CHANGE ORDER

Project Name: District 3, Year 3 Outfall Project

Change Order Number: 2- Final

WORK DIRECTIVE CHANGEDate of Issuance: September 29, 2021WDC Number: 2P.O.: 182032Project Number: NR 1903Project Name: District 3 Outfall ProjectContractor: Foster Marine Contractors, Inc.Contractor Phone: (561) 683-0034Engineer: Baxter - Woodman, Inc.Owner (Name, Address): City of Lake Worth Beach

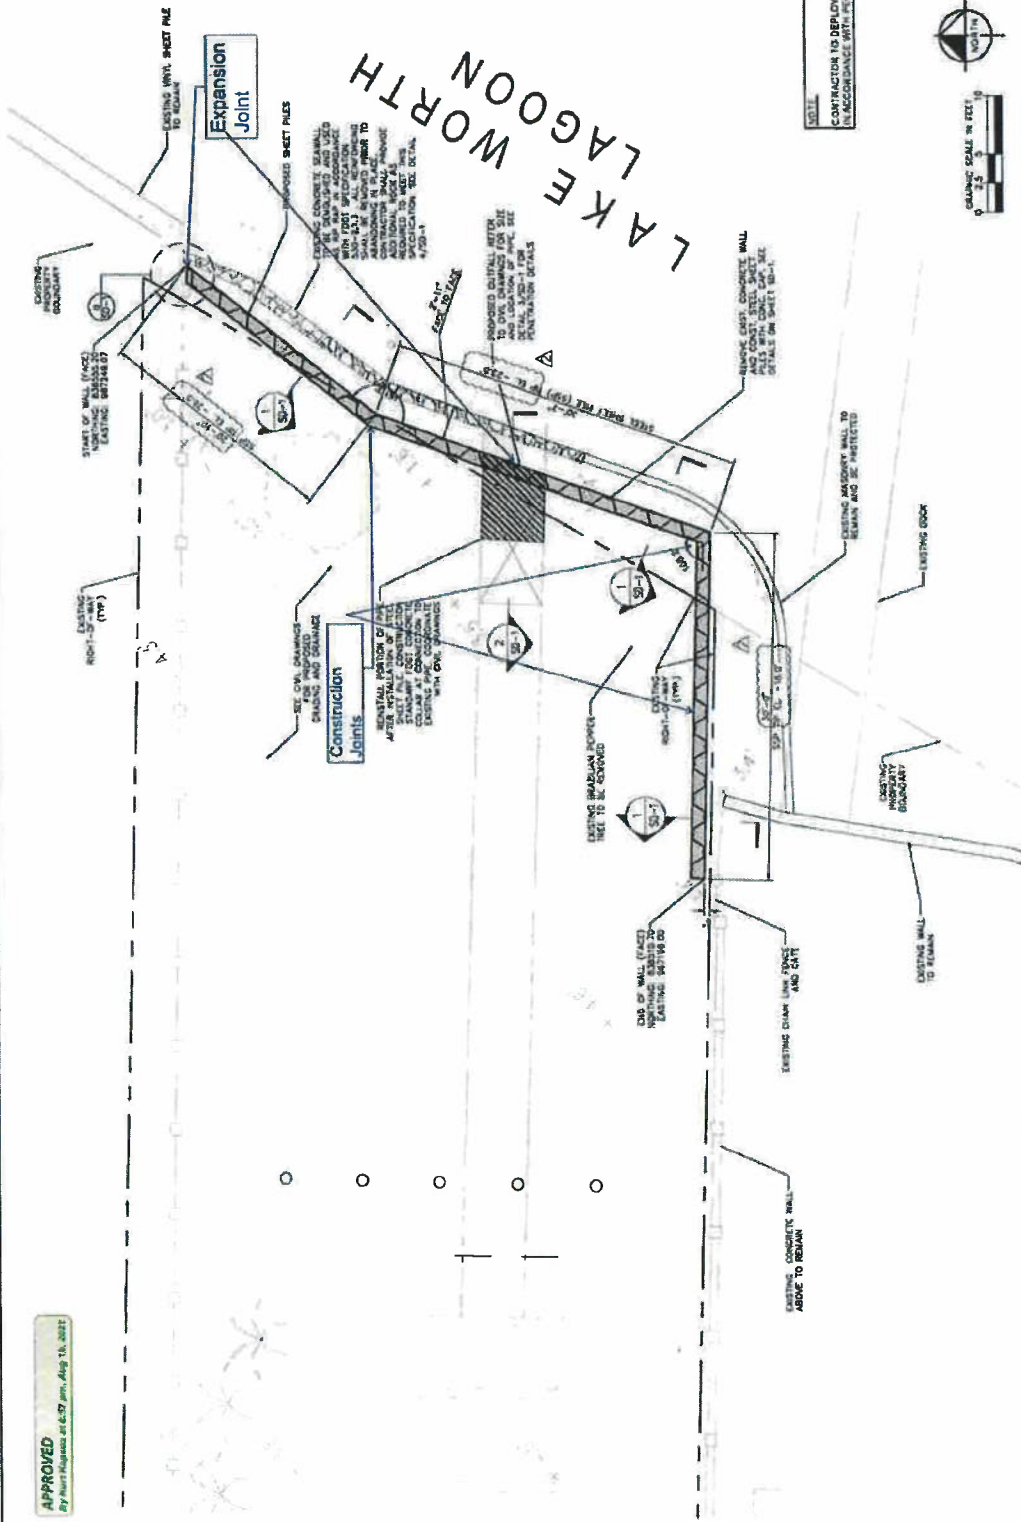
Response to comments on Cap Layout:

1. Detail 3/SD-2 is for an Expansion Joint and there is no detail given for the Construction Joints, they are two different types of control joints. Note 1 of detail 3/SD-2 describes the Construction Joint as a 1" V Groove along both faces and top of cap.

2. Wellesley Dr.'s cap joint lay out plan complies with the intent of the plans.
 - a) At the north end of the seawall there is an expansion joint between the new wall and the neighboring existing wall. Since the City does not own the existing wall to the north we cannot make a physical connection to it, dowels cannot be inserted.

- b) The wall is less than 75' in total length, so an expansion joint is not technically required, however there is one at the north end of the project.

- c) Detail 3/SD-2 note 1 states that Construction Joints be spaced at 25' max between Expansion Joints and at all changes of direction. The cap joint lay out plan shows a Construction Joint at the first bend in the seawall which is 22'5" south on the Expansion Joint, at the north end of the seawall. The next Construction Joint is located at the second bend in the seawall which is approximately 22'5" southwest of the first Construction Joint. The seawall then runs and then terminates approximately 15'10" to the west of the second construction joint. The total length of the wall is approximately 66' 8".

- d) Detail 3/SD-2 of contract draws details how to construct the Expansion Joint, no need to show a repetitive detail on the lay out drawing.

3. 18th Ave North cap joint lay out complies with the intent of the plans:
- a) At the north end of the seawall there is an expansion joint between the new wall and the neighboring existing wall. Since the City does not own the existing wall to the north we cannot make a physical connection to it, dowels cannot be inserted.

- b) 33.39' southwest from the north end of the seawall there is another Expansion Joint. The total length of the wall is approximately 81.41', therefore the layout of the Expansion Joints complies with the intent of the plans.

- c) The cap joint plan shows 3ea Construction Joints, one at each bend in the wall, (2ea) and another one centered on the south return wall. None of the Construction Joints are more than 20'10" from another Construction Joint or Expansion Joint, this complies with detail 3/SD-2 note 1 "Construction Joints be spaced at 25' max between Expansion Joints and at all changes of direction."

- d) Detail 3/SD-2 of contract draws details how to construct the Expansion Joint, no need to show a repetitive detail on the lay out drawing.
4. Detail 3/SD-2 is intended for a steel sheet pile wall, not a concrete king panel wall. Steel sheet piling and concrete expand and contract at different rates making more of a need an Expansion Joint. A concrete panel wall tends to expand and contract at the same rate making the Expansion Joint less needed. I also feel that adding the dowels to the Expansion Joint is more problematic then beneficial, especially in a saltwater environment, as it creates a spot to promote premature corrosion of the reinforcing steel.

PROJECT Lake Worth outfall - Typical Cap Detail @ Pile

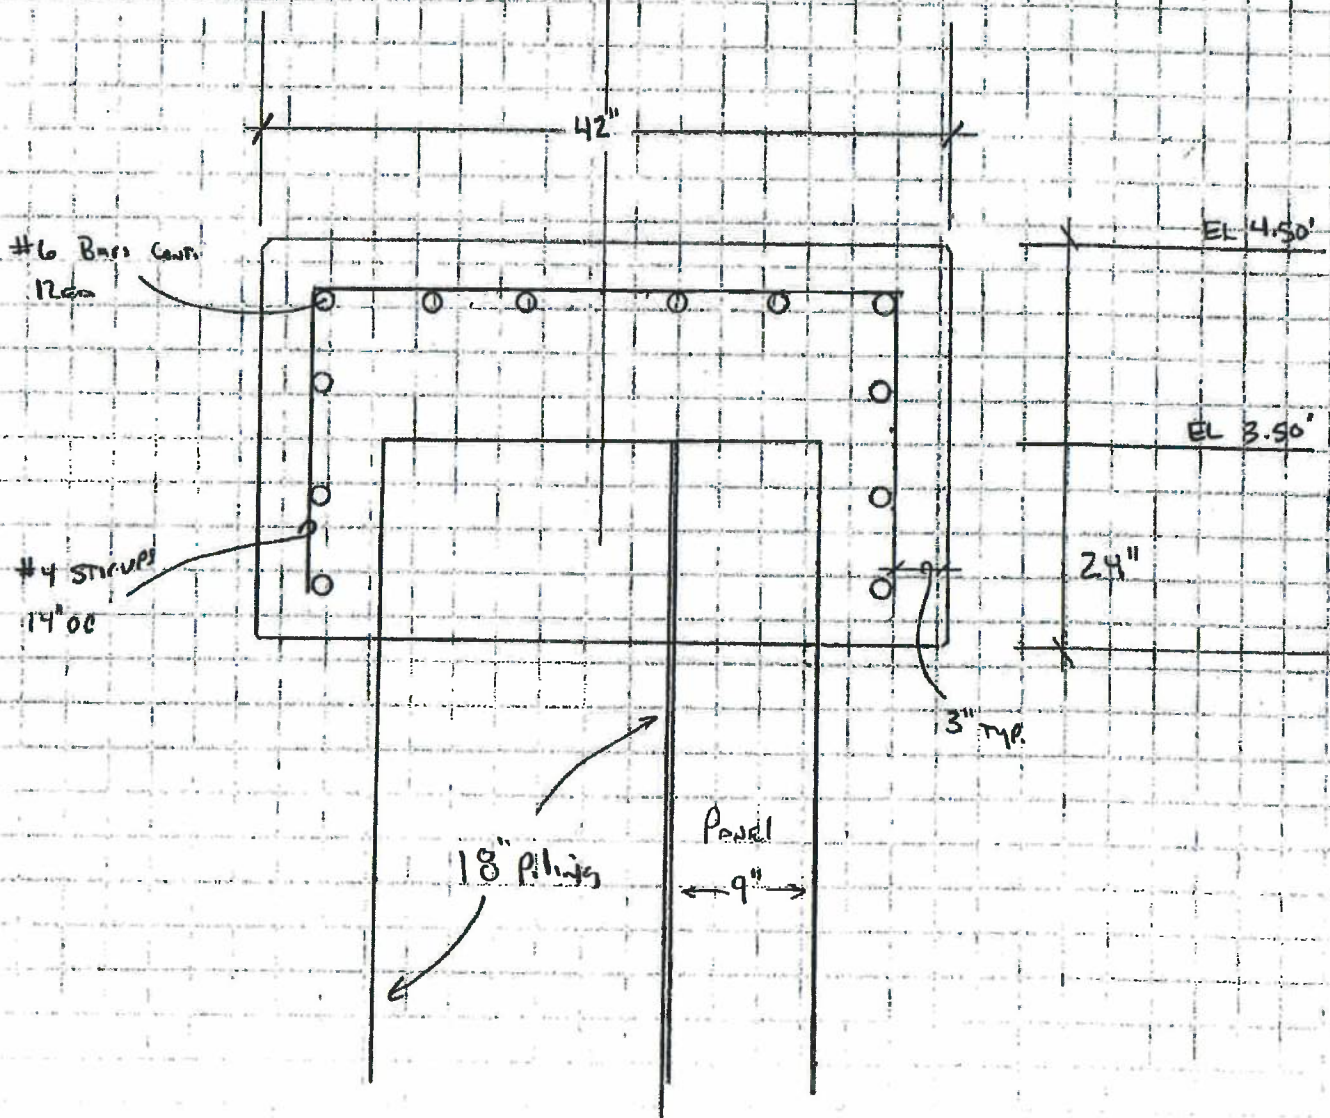
1. The alternate cap detail was provided in good faith with the intent of giving the City of Lake Worth (in my opinion) a better seawall cap design than the one provided on the drawings, at no additional cost to the City. The design given was based on past projects which utilized the same reinforcing steel layout and clearances as shown on the alternate cap detail submitted. Murray Logan Construction, Inc has installed thousands of feet of cap constructed to this detail, with no failures. Murray Logan Construction, Inc will install the alternate cap, per the design submitted by Murray Logan Construction, Inc. at no additional cost to the City.

If the City of Lake Worth wishes to have the cap constructed to the alternate cap design including the additional reinforcing steel added by the EOR, Murray Logan Construction, Inc will need to request a change order to cover the cost of the additional labor and materials needed to meet the design.

PROJECT Lake Worth Off II - Typical Cap Detail @ Panel (only)

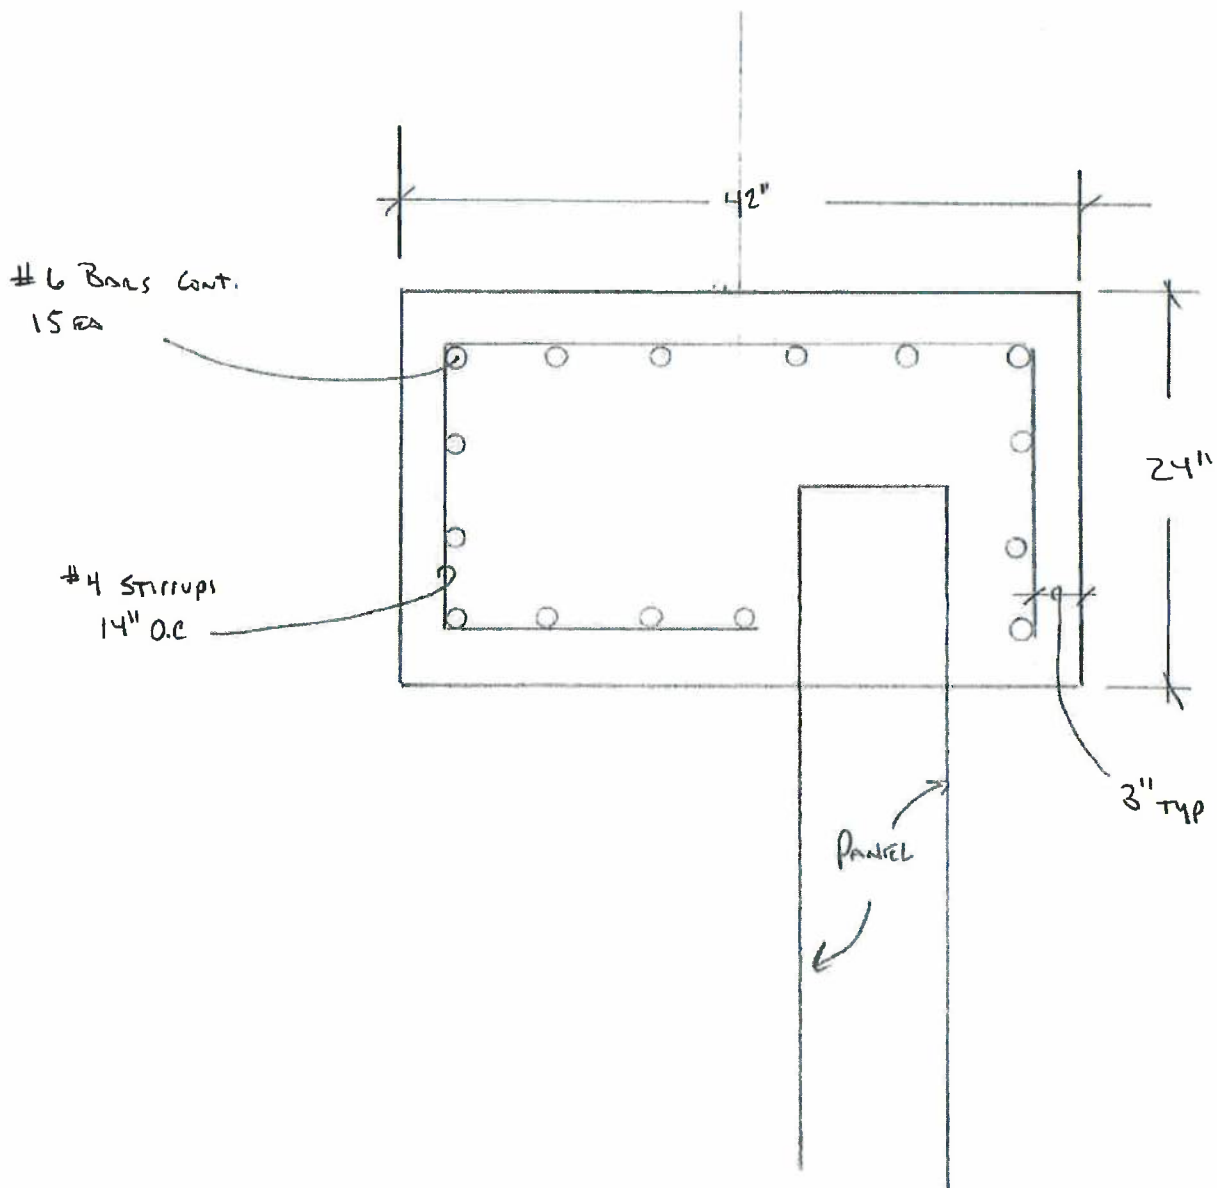
It is my opinion that we have all thought about the design of the cap than K-H ever did! Kurt's design provides more concrete/rebar "meat" on the Piles / Panel sides and has 12 continuous #6 bars to 10 on the K-H design. Adding more bars to Kurt's design he would be due a Change Order for additional Materials. Murray Logan has built thousands of feet of seawall over 60 years of being in business. FMC has to warranty this installation and we would feel more comfortable doing that with Kurt's design than k-H design. I would bet a dollar that the designer at K-H hasn't ever seen a seawall built and just used a previous design they had in their archives and copied to this plan. Please, I am requesting we leave K-H out of this discussion or we will be delayed weeks before we could get them to answer.

Adding more bars to Kurt's design he would be due a Change Order for additional Materials. The bottom mat in K-H design serves no purpose; the cap is bearing on the pile and panel below. Using that material in the concrete on the side of the panels and piles makes a lot of sense....and with no price increase.

PROJECT 18TH AVE - PROPOSED CAP TO EXISTING HEADWALL

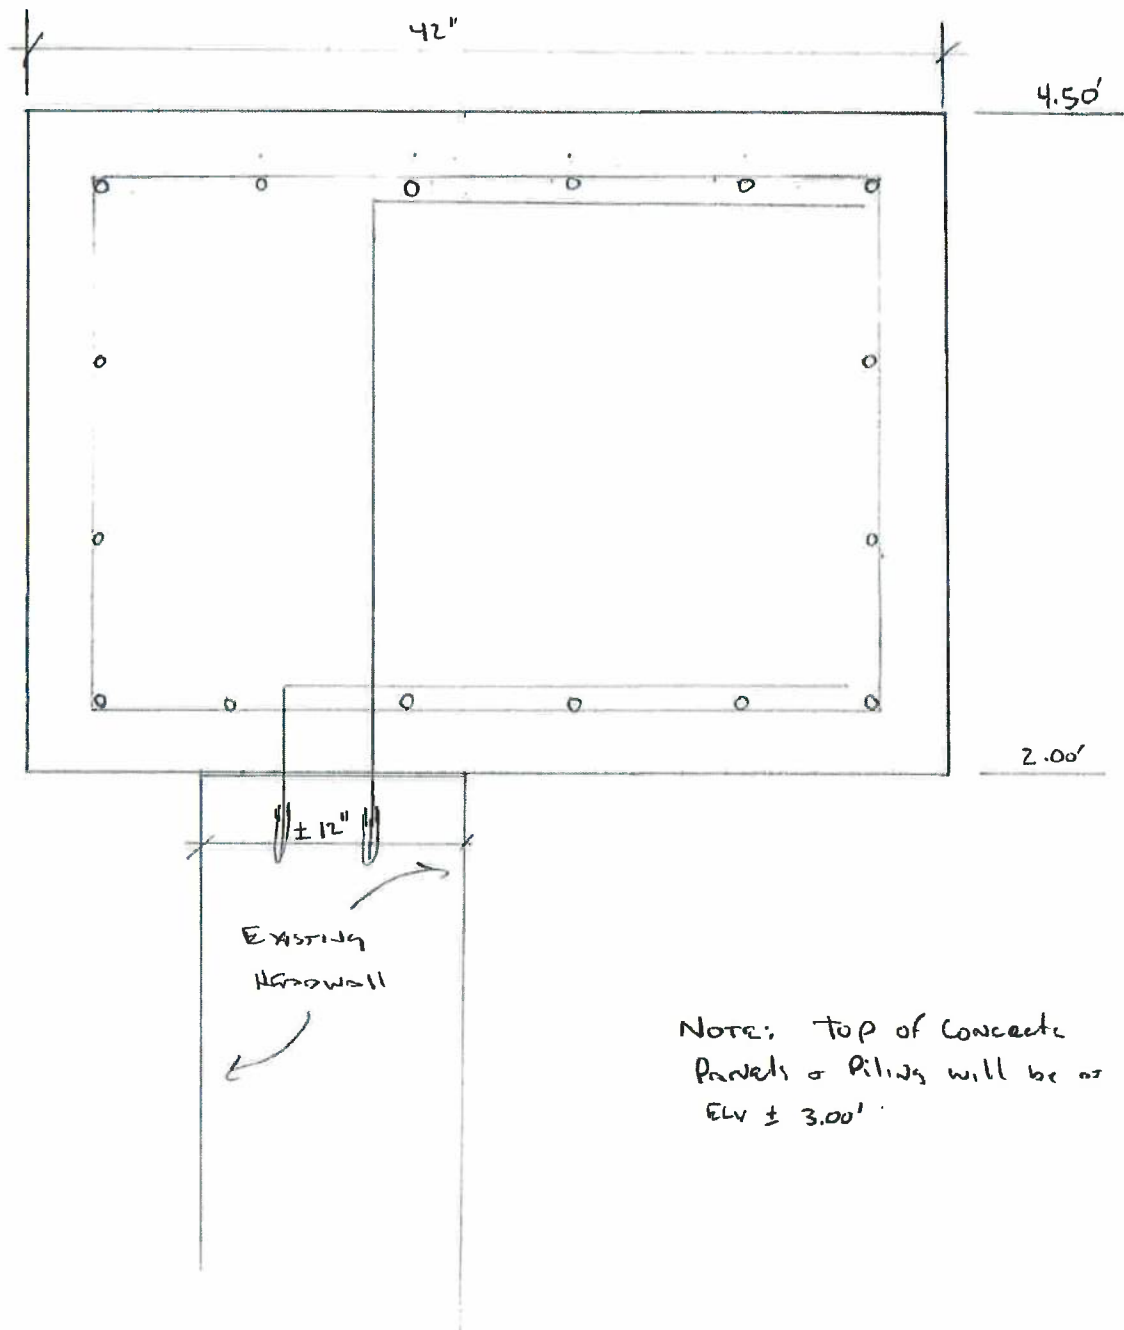
1. Construct seawall cap in accordance with revised design approved by the City with no contract price increase.
2. Delete removal and replacement of 54" pipe and approximately 20 LF of adjacent existing seawall and construct modified cap for existing seawall at the 18th Ave. N. outfall for a net savings of (\$13,042.50) in accordance with contractor's itemized proposal.

WDC 2 - At 18th St N, Existing Headwall and 54" Outfall Pipe to remain; Cap to be increased vertically on top of Headwall in order for the Cap Finish Grade Elev (+4.50) to be flush with Proposed Cap on each side of Headwall							
GC-9.1	54" RCP, incl. conn. To exist.	-8	LF		\$1,470.00	\$	(11,760.00)
S-2	Concrete Cap (increase to raise cap vertically on seawall to elev 4.5)	13.25	CY	\$	1,600.00	\$	21,200.00
S-3	Reinforcing Steel for Cap	0.605	TN	\$	2,500.00	\$	1,512.50
S-6	Removal of Existing Concrete Structures (Headwall not removed)	-0.21	LS	\$	19,000.00	\$	(3,990.00)
A-2	Concrete Posts	-2.00	EA	\$	5,180.00	\$	(10,360.00)
A-3	Concrete Panels	-5.00	EA	\$	3,670.00	\$	(18,350.00)
--	Vinyl Sheet Pile return at end	1.00	LS	\$	2,071.00	\$	2,071.00
--	18" sq x 26' concrete pile (material only...supplier would not take back... will deliver to LW yard)	52.00	LF	\$	17.00	\$	884.00
--	Closure pours	2.00	2500.00	\$	2,875.00	\$	5,750.00
